Project: IEEE P802.15 Working Group for Wireless Personal Area Networks (WPANs)

Submission Title: [Comment resolution on the color function support]

Re: [Response to the SB 1st recirculation for the IEEE 802.15.7 standard]

Comment resolution on the color function support

Figure 36—CVD frame usage for acknowledgment indication

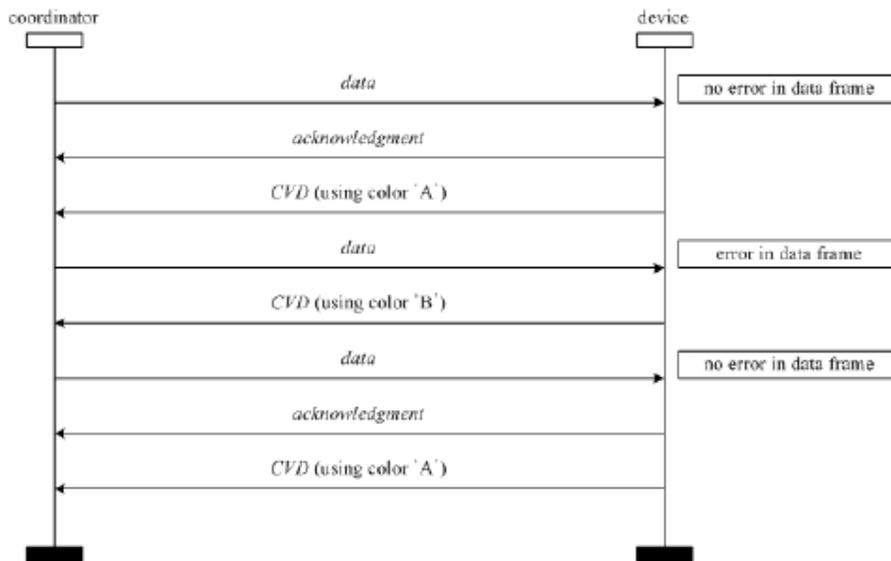
Comment No.	Name	Page	Subclause	Line	Comment	Proposed Change
80	Walewski, Joachim	67	5.1.12.2	29	Sloppy grammar?	Replace "receives some data" with "receives data"

- Figure 36 shows an example of how the user can infer whether a receiver successfully receives some data or not.

- Figure 36 shows an example of how the user can infer whether a receiver successfully receives some data or not.

- Accept

- Change “Figure 36 shows an example of how the user can infer whether a receiver successfully receives **some** data or not.” on line 29, page 67 to “ Figure 36 shows an example of how the user can infer whether a receiver successfully receives ~~**some**~~ data or not.”

Figure 36—CVD frame usage for acknowledgment indication

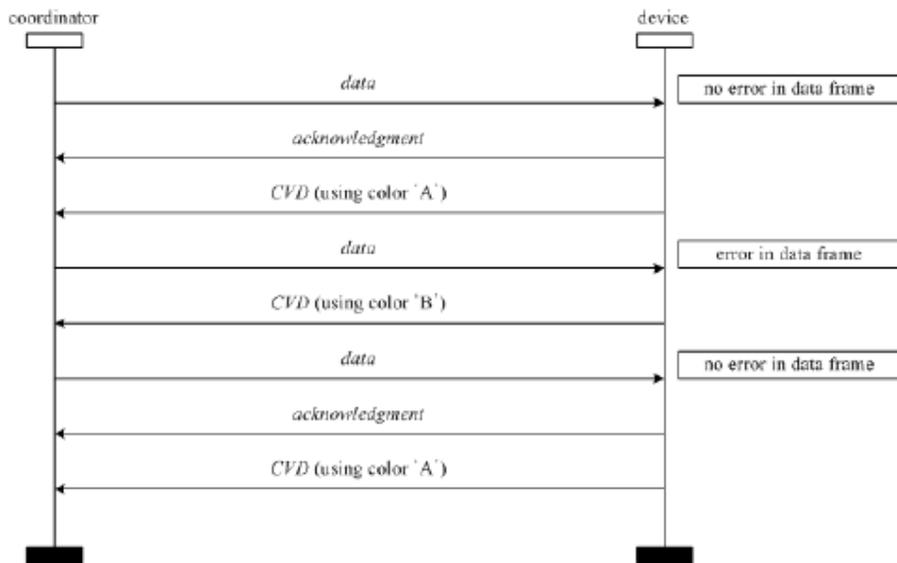
Com ment No.	Name	Page	Subclau se	Line	Comment	Proposed Change
81	Wale wski, Joach im	67	5.1.12 .2	30	Uneven style.	Replace "According to Figure 36, the device sends the CVD frame after the ACK frame has been sent." with "According to THIS FIGURE, the device sends A CVD frame ..." (Capitals: my emphasize.)

- According to Figure 36, the device sends the CVD frame after the ACK frame has been sent.

- According to this figure, the device sends a CVD frame after the ACK frame has been sent.

- Accept

- Change “According to **Figure 36**, the device sends **the CVD** frame after the ACK frame has been sent.” on line 30, page 67 to “According to **this figure**, the device sends **a CVD** frame after the ACK frame has been sent.”

Figure 36—CVD frame usage for acknowledgment indication

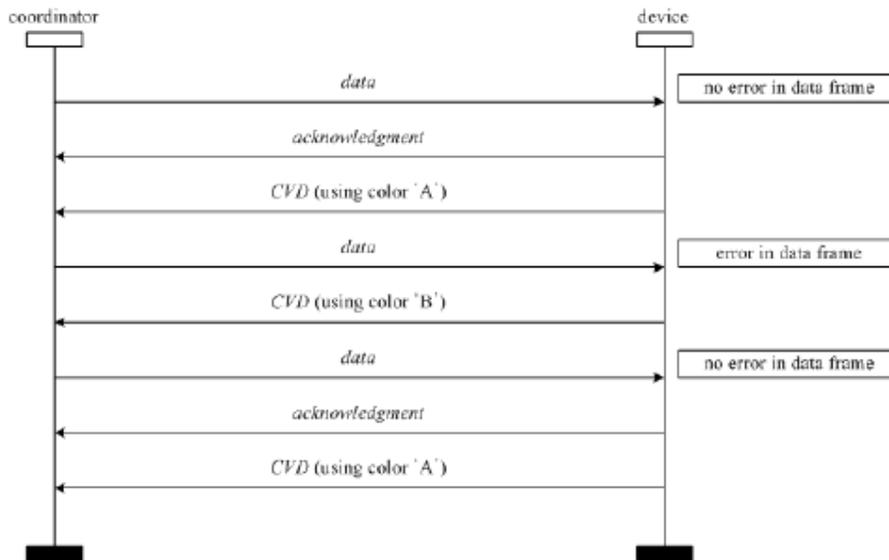
Com ment No.	Name	Page	Subcla use	Line	Comment	Proposed Change
82	Wale wski, Joach im	67	5.1.12 .2	31	Sloppy grammar?	Replace "received data has some errors" with "received data has errors".

- The CVD frame can indicate that the received data has some errors or is error-free, based on the choice of colors.

- The CVD frame can indicate that the received data has ~~some~~ errors or is error-free, based on the choice of colors.

- Accept

- Change "The CVD frame can indicate that the received data has some errors or is error-free, based on the choice of colors." on line 31, page 67 to " The CVD frame can indicate that the received data has ~~some~~ errors or is error-free, based on the choice of colors."

Figure 36—CVD frame usage for acknowledgment indication

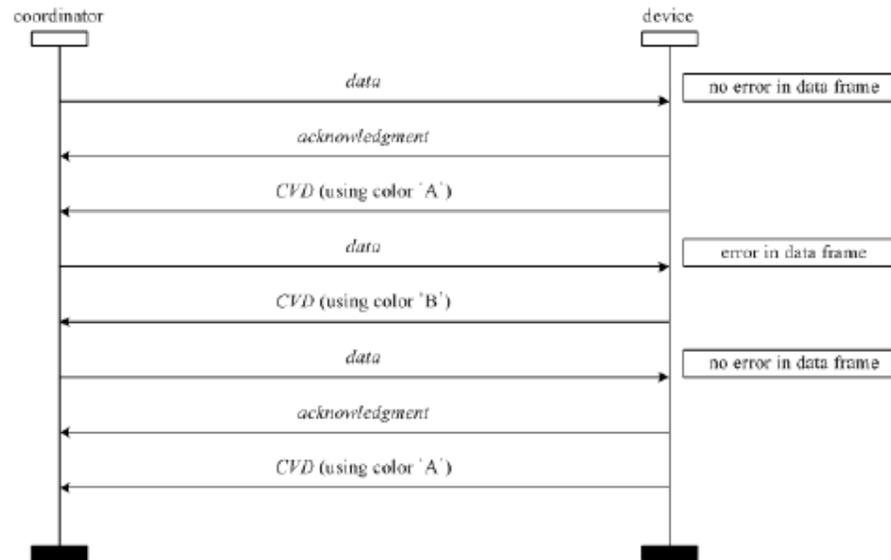
Com ment No.	Name	Page	Subcla use	Line	Comment	Proposed Change
83	Wale wski, Joach im	67	5.1.12 .2	32	How can the CVD frame use anything: "the color function for the ACK state indication is used by the CVD frame"	Change wording. Example: "the color of the CVD frame is set according to the ACK-state indication"

- The MAC PIB attribute, *macColorReceived* as shown in Table 59, is used for the color assignment of the CVD frame when the ACK frame is sent and the color function for the ACK state indication is used by the CVD frame.

- The MAC PIB attribute, *macColorReceived* as shown in Table 59, is used for the color assignment of the CVD frame when the ACK frame is sent and the color of the CVD frame is set according to the ACK-state indication.

- The MAC PIB attribute, *macColorReceived* as shown in Table 59, is used for the color assignment of the CVD frame when the ACK frame is sent and the color function for the ACK state indication is achieved by the CVD frame.

- Principle

- Change "The MAC PIB attribute, *macColorReceived* as shown in Table 59, is used for the color assignment of the CVD frame when the ACK frame is sent and the color function for the ACK state indication is **used** by the CVD frame." on line 33, page 67 to " The MAC PIB attribute, *macColorReceived* as shown in Table 59, is used for the color assignment of the CVD frame when the ACK frame is sent and the color function for the ACK state indication is **achieved** by the CVD frame."

Figure 36—CVD frame usage for acknowledgment indication

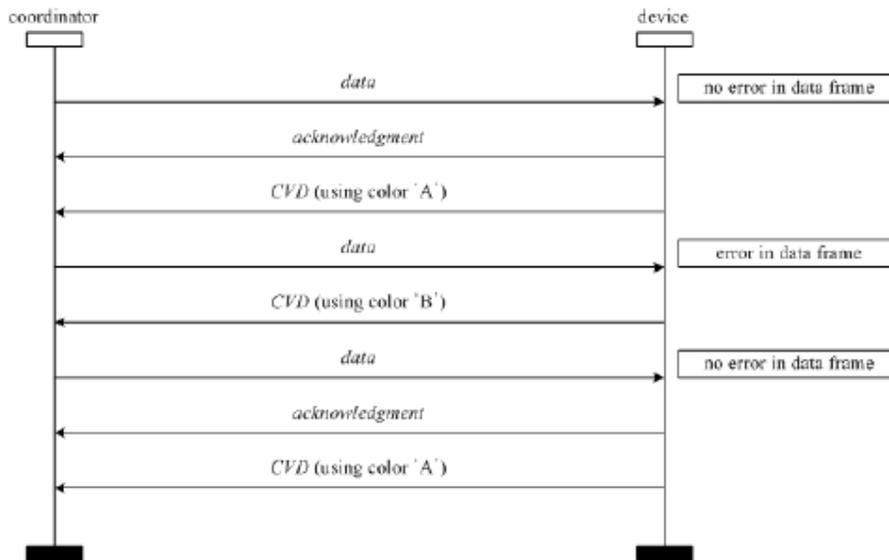
Comment No.	Name	Page	Subclause	Line	Comment	Proposed Change
84	Walewski, Joachim	67	5.1.1 2.2	33	I simply do not comprehend the last sentence of this paragraph.	Rewrite sentence so that it makes sense. I offer to draft a resolution in concert with the authors of the paragraph.

- The MAC PIB attribute, *macColorNotReceived* as shown in Table 59, is used for the color assignment of the CVD frame when the ACK frame is not sent but the color function for the non-ACK state indication is used by the CVD frame.

- An ACK frame is sent to the other device, but a NACK frame is not sent to the other device in IEEE 802.15.7 draft.
 - So, we can say what an ACK frame is not sent means the NACK state
1. An ACK frame is sent and a CVD frame to show ACK state is sent.
 2. An ACK frame is sent but a CVD frame to show ACK state is **not sent**.
 3. An ACK frame is not sent and a CVD frame to show NACK state is **not sent**.
 4. An ACK frame is not sent but a CVD frame to show NACK state is sent.

- We don't need the color assignment of the CVD frame for 2nd case or 3rd case because the CVD frame, itself, is not sent in these cases.
- *MacColorReceived* is used for the color assignment of the CVD frame for 1st case.
- *MacColorNotReceived* is used for the color assignment of the CVD frame for 4th case.
- The MAC PIB attribute, *macColorNotReceived* as shown in Table 59, is used for the color assignment of the CVD frame when the ACK frame is not sent but the color function for the non-ACK state indication is ~~used~~ **achieved** by the CVD frame.

- Accept

- Change "The MAC PIB attribute, *macColorNotReceived* as shown in Table 59, is used for the color assignment of the CVD frame when the ACK frame is not sent but the color function for the non-ACK state indication is **used** by the CVD frame." on lines 34 to 36, page 67 to "The MAC PIB attribute, *macColorNotReceived* as shown in Table 59, is used for the color assignment of the CVD frame when the ACK frame is not sent but the color function for the non-ACK state indication is ~~used~~ **achieved** by the CVD frame."

Figure 37—Example of MSC for CVD frame usage for file-transfer status indication

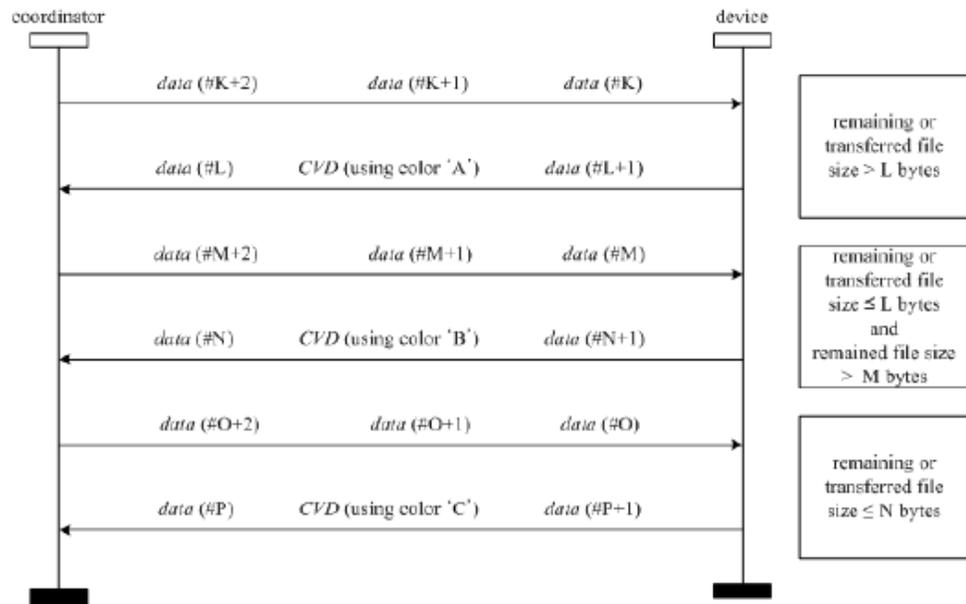
Com ment No.	Name	Page	Subcl ause	Line	Comment	Proposed Change
85	Wale wski, Joach im	68	5.1.1 2.4	42	Confusing indication of a qualifying sentence, while the sentence actually is not qualifying.	Replace "For example, in order to use ..." with "In order to use ..."

- For example, in order to use this indication the device needs to know the total file size to be transmitted.
- ↓
- In order to use this indication the device needs to know the total file size to be transmitted.

- Accept

- Change " **For example, in order to use this indication** the device needs to know the total file size to be transmitted." on line 42 in page 68 to "**In order to use this indication**, the device needs to know the total file size to be transmitted."

Figure 35—Example of CVD frame usage MSC for association

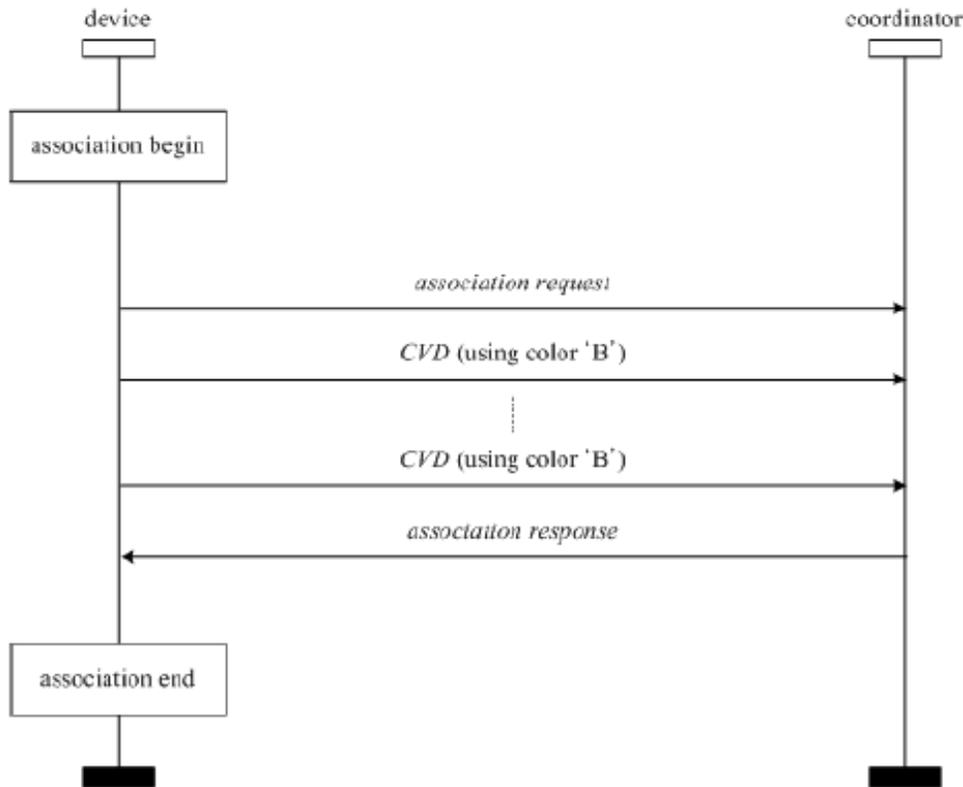
Com ment No.	Name	Page	Subcla use	Line	Comment	Proposed Change
313	Wale wski, Joach im	66	5.1.12 .1	11	This sentence reads rather awkwardly.	Replace "using a chosen color." with "and indicates this to the user with a chosen color."

- For example, the device sends an association request to the coordinator (see Figure 35) using a chosen color.

- For example, the device sends an association request to the coordinator (see Figure 35) and indicates this to the user with a chosen color.

- Accept

- Change "For example, the device sends an association request to the coordinator (see Figure 35) **using a chosen color.**" on line 11 in page 66 to "For example, the device sends an association request to the coordinator (see Figure 35) **and indicates this to the user with a chosen color.**"

Figure 35—Example of CVD frame usage MSC for association

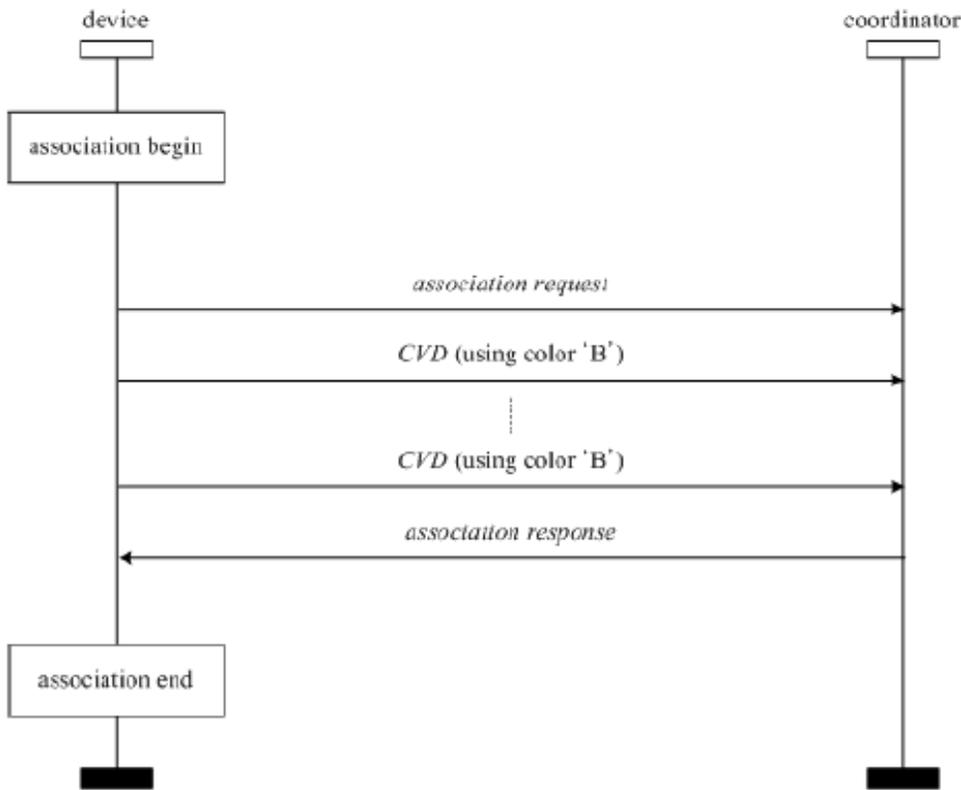
Com ment No.	Name	Page	Subcla use	Line	Comment	Proposed Change
314	Wale wski, Joach im	66	5.1.1 2.1	42	This Figure caption reads rather awkwardly.	Replace "Example of CVD frame usage MSC for association! with "MSC for association when color- function-support is invoked."

- Figure 35—Example of CVD frame usage MSC for association
↓ Commentor's recommendation
- Figure 35—MSC for association when color-function-support is invoked
↓ Our recommendation
- Figure 35—MSC when color function for association indication is invoked

- Principle

- Change “Figure 35—Example of CVD frame usage MSC for association” on line 42, page 66 to “Figure 35—**MSC when color function for association indication is invoked**”
